MSD ADDENDUM

Replacement Pro Cap Rotor Fits Distributor PN 7445 PN 7424

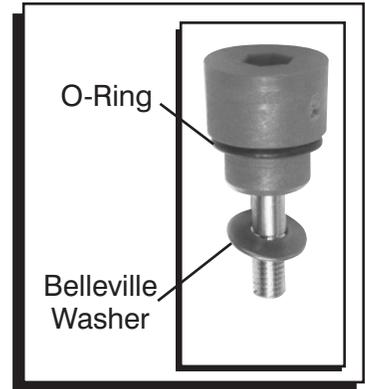
Install the rotor making sure that it is placed correctly on the mount and the alignment dowels are seated before installing the rotor hold down screws. Install one O-ring on each of the over-molded rotor screws for increased spark isolation as well as a belleville washer. Torque screws to 30-32 in-lbs.

Note: Torque the over-molded plastic hex screws to 30-32 in-lbs. When installing the rotor, each screw should be equipped with an O-ring and belleville washer (dome facing upward).

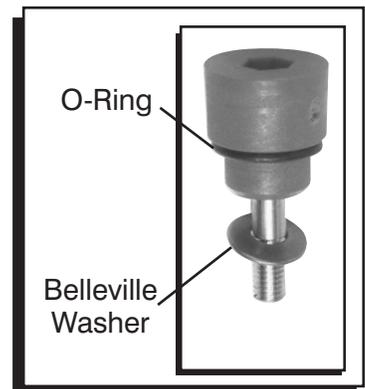
Install the rotor making sure that it is placed correctly on the mount and the alignment dowels are seated before installing the rotor hold down screws. Install one O-ring on each of the over-molded rotor screws for increased spark isolation as well as a belleville washer. Torque screws to 30-32 in-lbs.

Note: Torque the over-molded plastic hex screws to 30-32 in-lbs. When installing the rotor, each screw should be equipped with an O-ring and belleville washer (dome facing upward).
